Technical Bulletin

Accessory case and engine accessories

SPORTAVIA LIMBACH SL 1700 E, EI

Fig. 1 Crankcase, old and new version

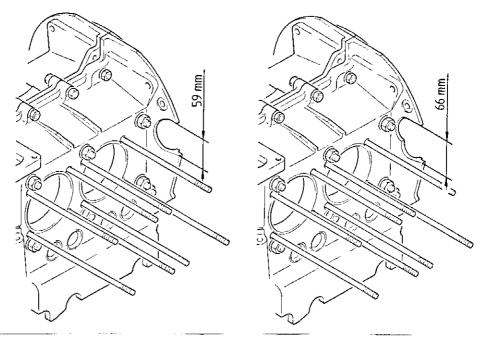
The crankcase has a different cut-out for the starter. (Old version 59mm, new 66mm Fig. 1.)

Engines already in service can have the cut-out in their crankcase modified.
